MCIP ROADWAY IMPROVEMENTS
 TOWN OF ADDISON, TEXAS

TDA NO. 2002-102
 MCIP PROJECT NO. 10305
 ADDISON RD - FROM BELT LINE RD TO ARAPAHO RD

This record drawing is a compilation of the sealed engineering drawing for this project, modified by addenda, change orders and information furnished by the contractor. The information shown on the record drawings that was provided by the contractor or others not associated with the design engineer cannot be verified for accuracy or completeness. The original sealed drawings are the property of the engineer, architects & others, LLC.

REVISION
 ELECTRICAL VOLTAGE CHANGES - OCTOBER 24, 2007

DETAIL 'C' PLAN
 STA. 9+97.75 TO STA. 12+66.25
 SCALE 1" = 10'

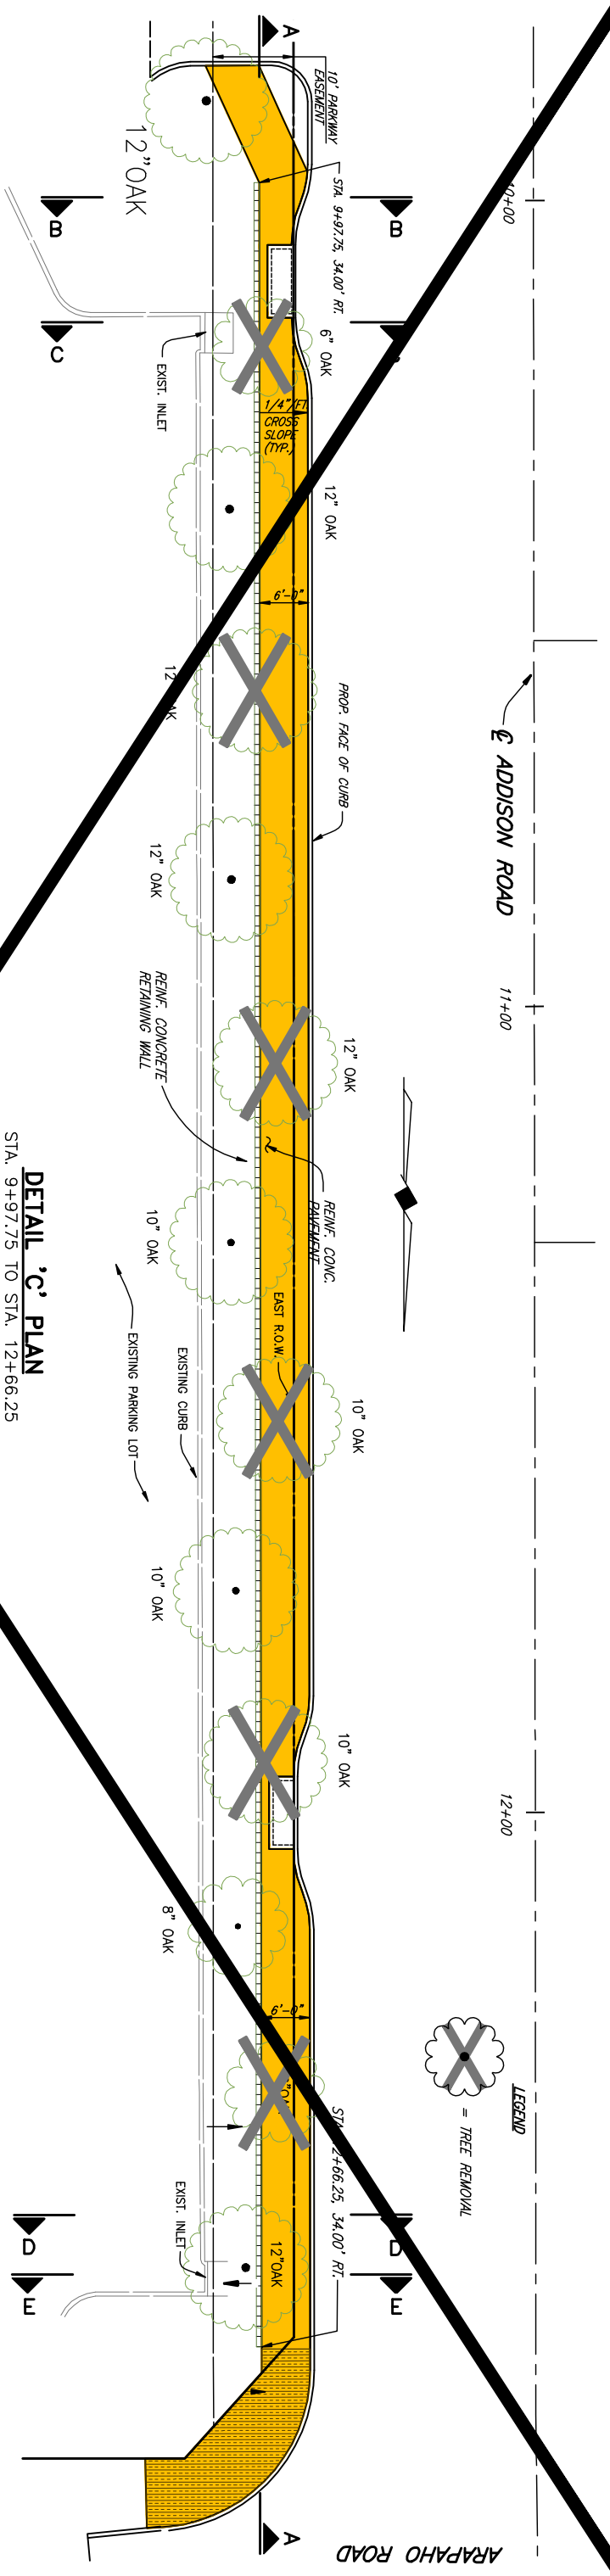
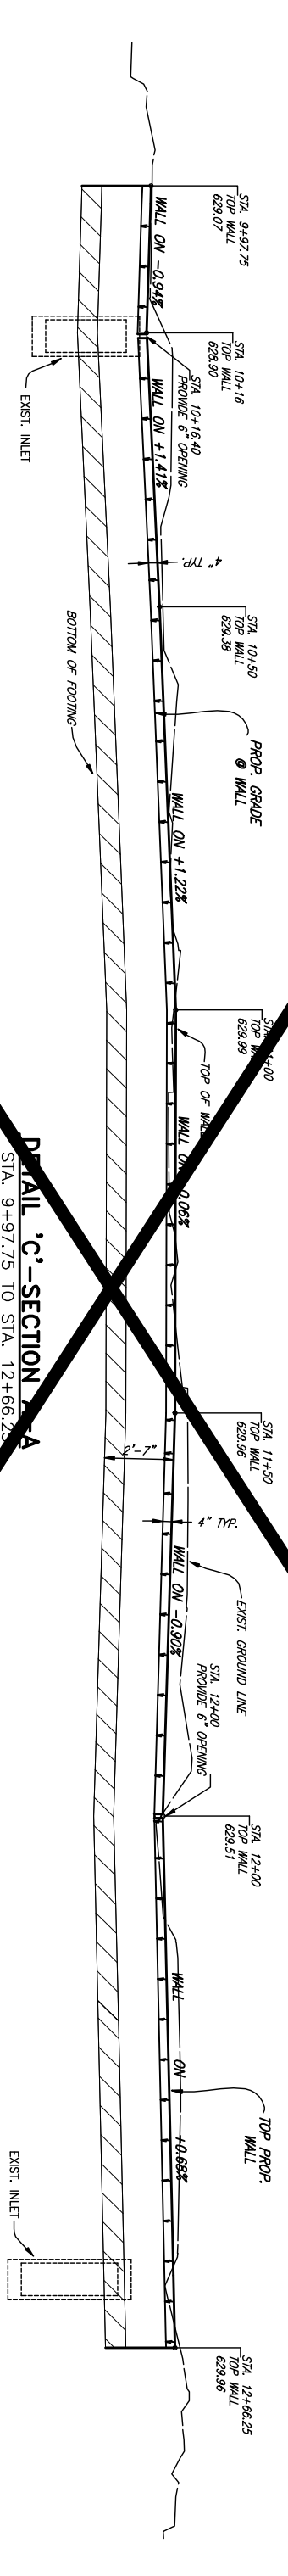
DELETE THIS SHEET

ADDISON ROAD IMPROVEMENTS
BELT LINE ROAD TO ARAPAHO ROAD PHASE I
STORM SEWER PLAN - STA. 0+00 TO STA. 4+00

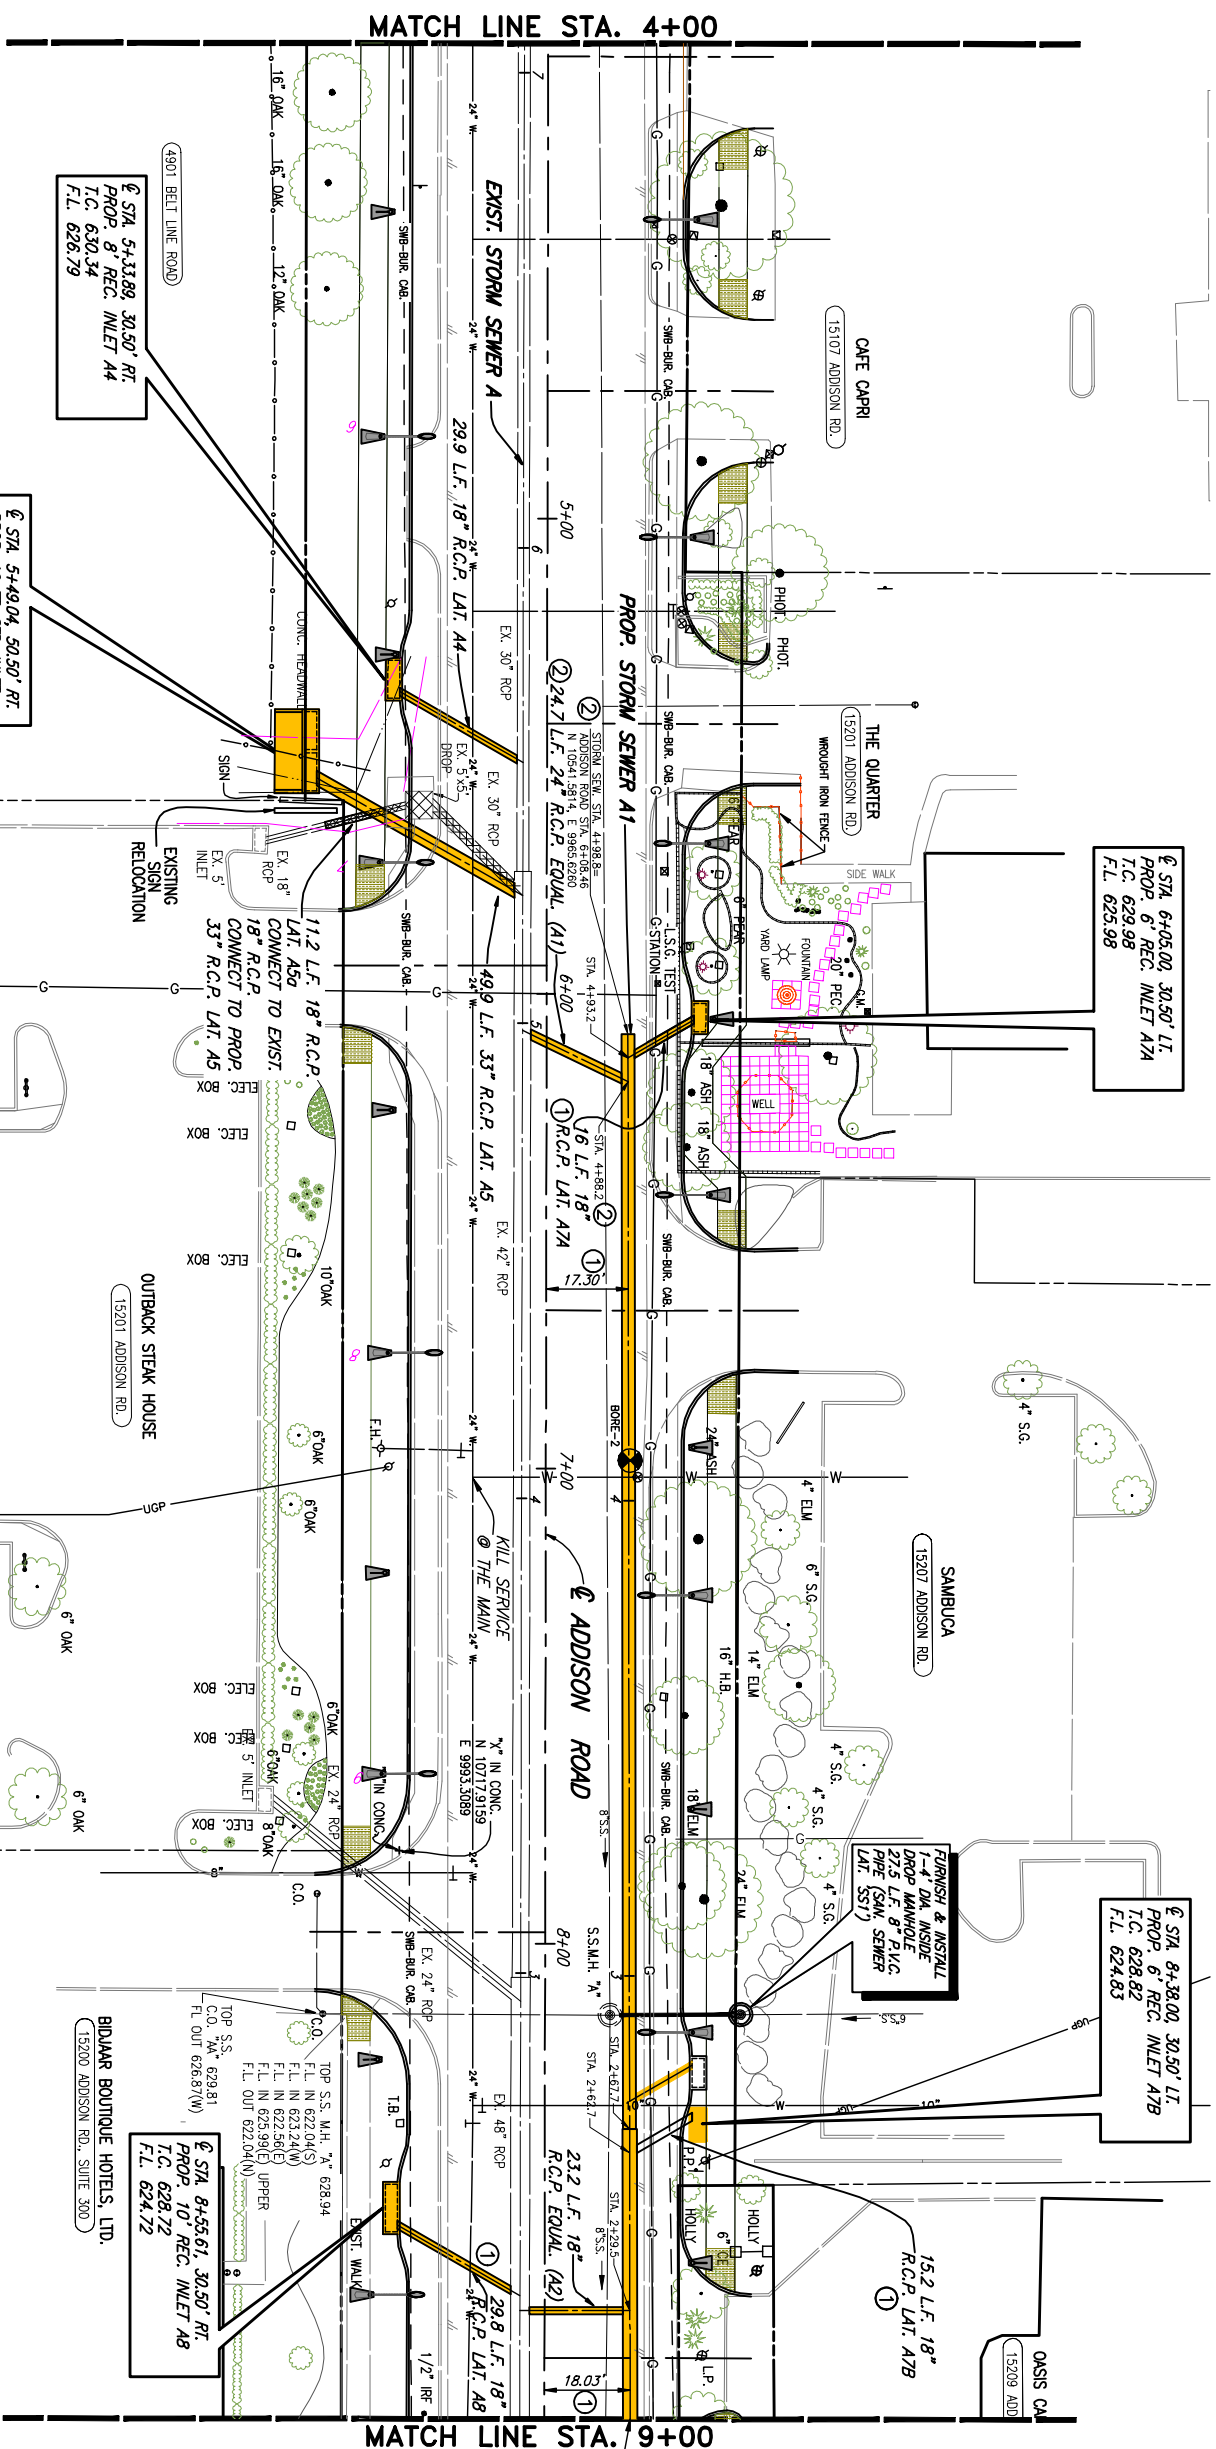
REMOVE & RELOCATE EXISTING FIRE HYDRANT 2.5 FT. WEST

FIELD CHANGE NO. 1 MARCH 22, 2007

1 ROADWAY LIGHTING - PART 'A'
SCALE: 1" = 10'-0"

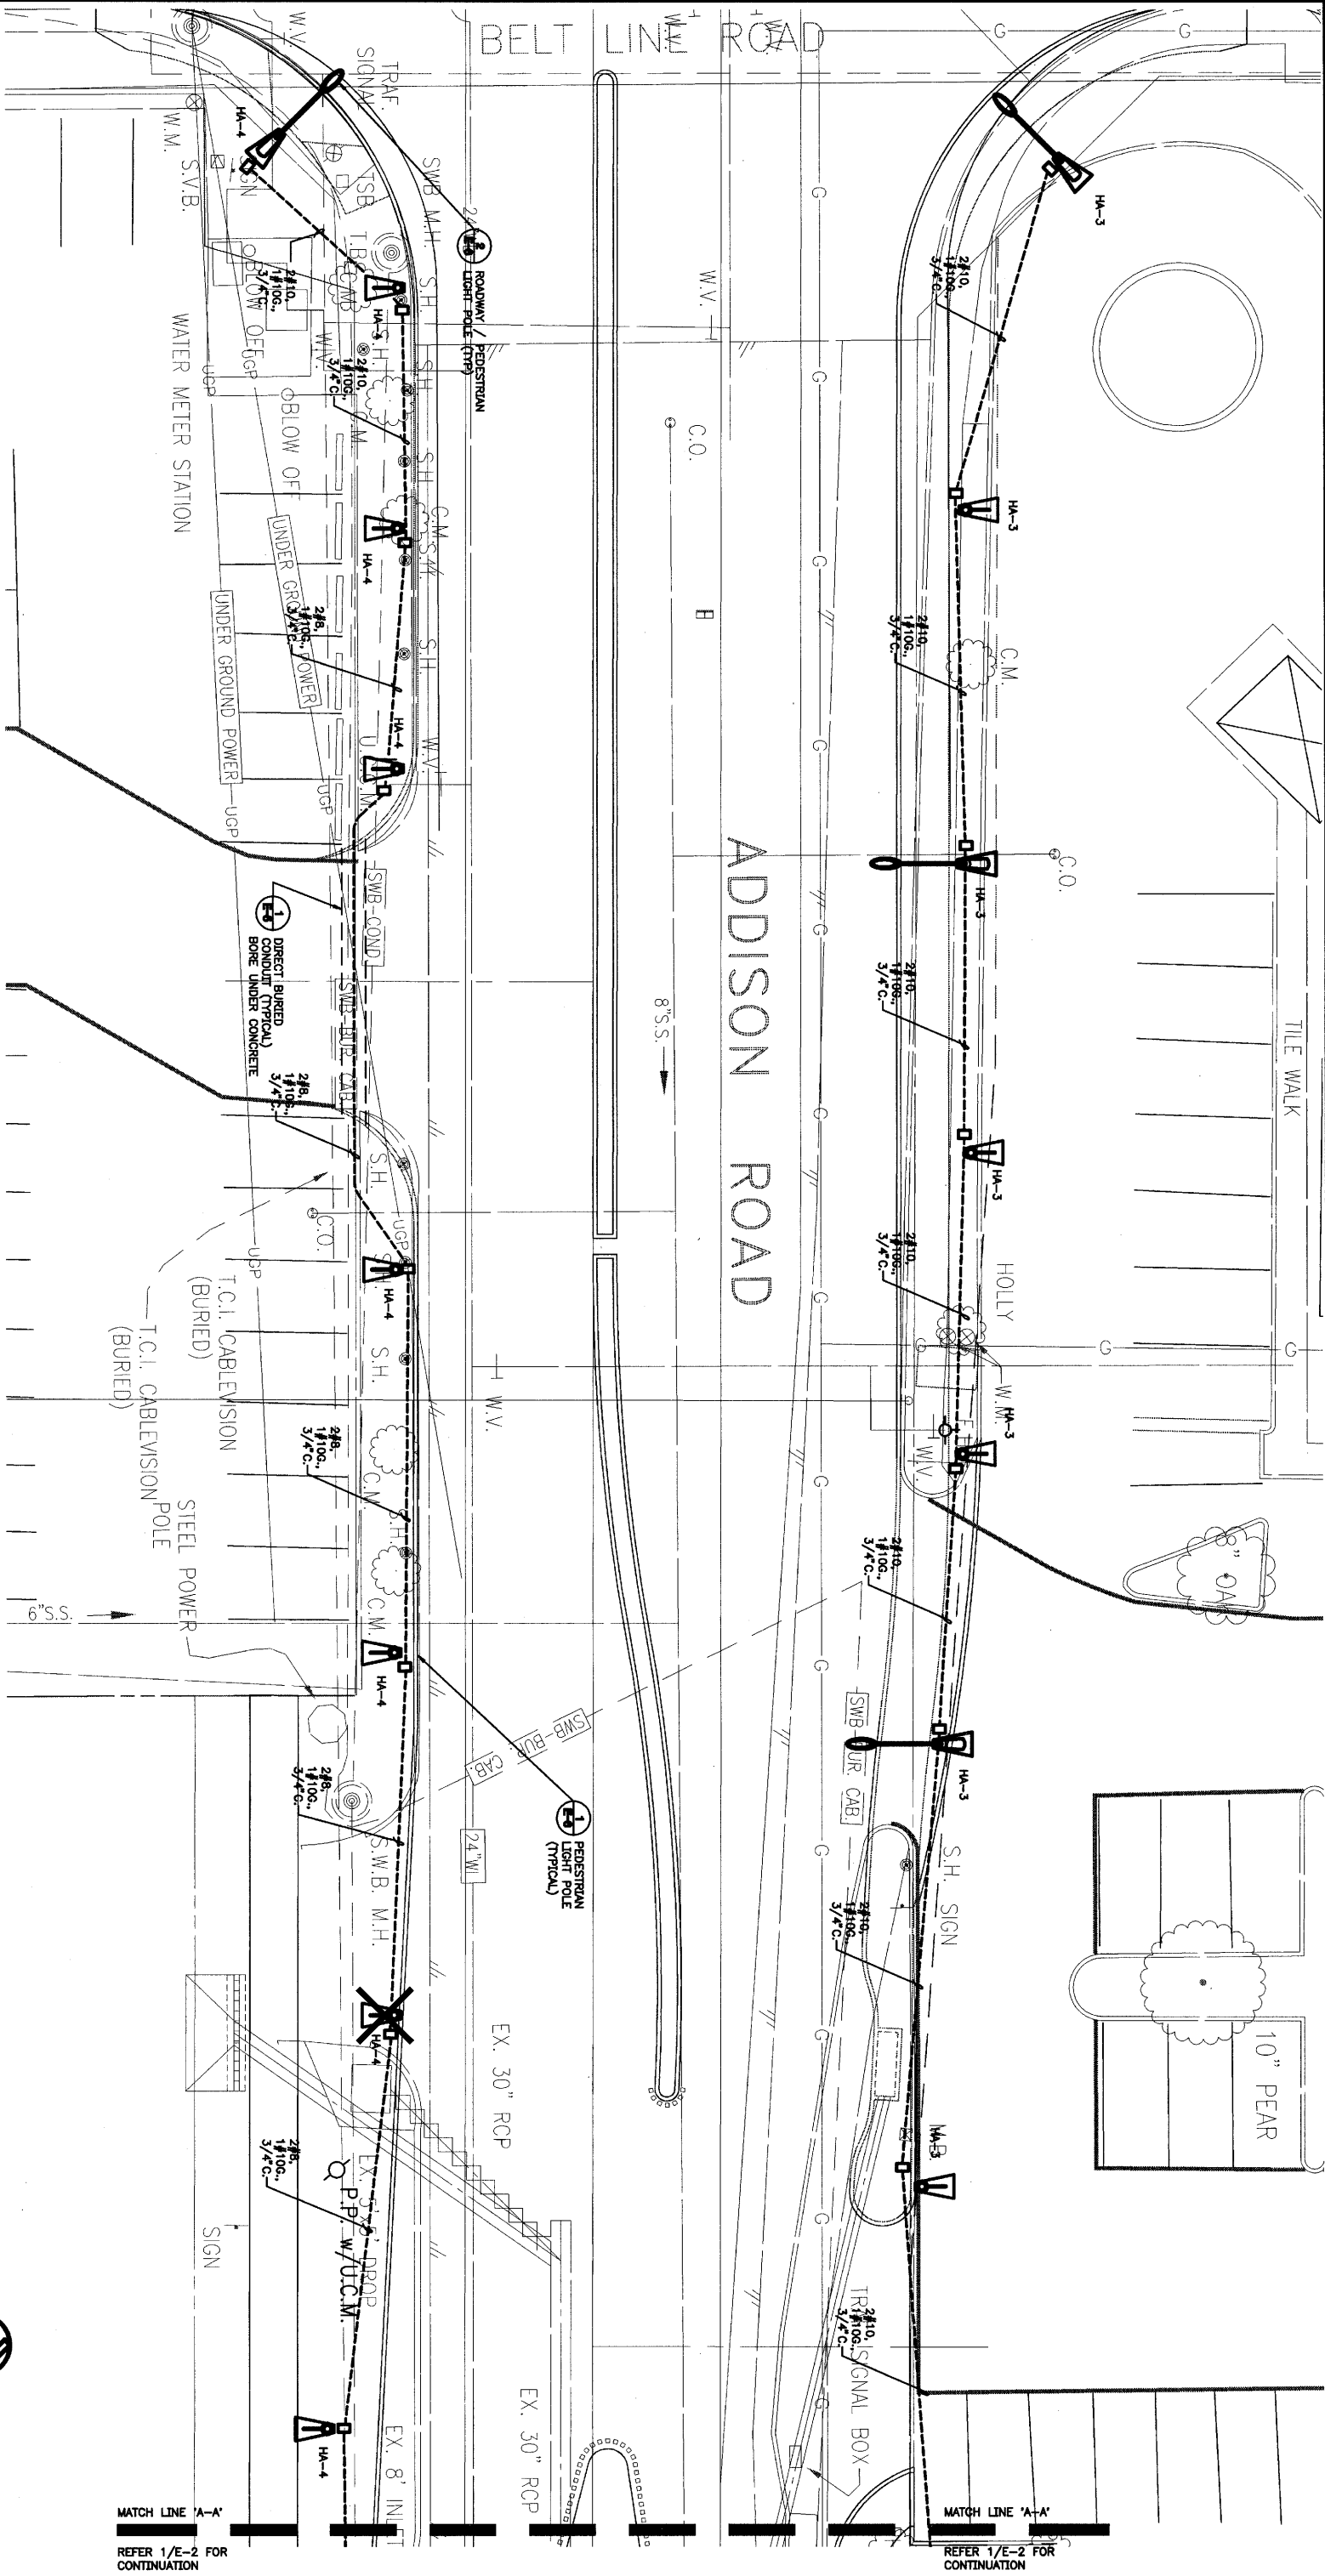
- A. Sheet No. 63 (Drawing E-1): Roadway Lighting - Part "A"
 1. Add an additional Utility Service/Detail 2/E-5 for a total of two (2) Utility Services. One service will serve Roadway Lighting exclusively and the other service will serve Pedestrian and Irrigation Systems.
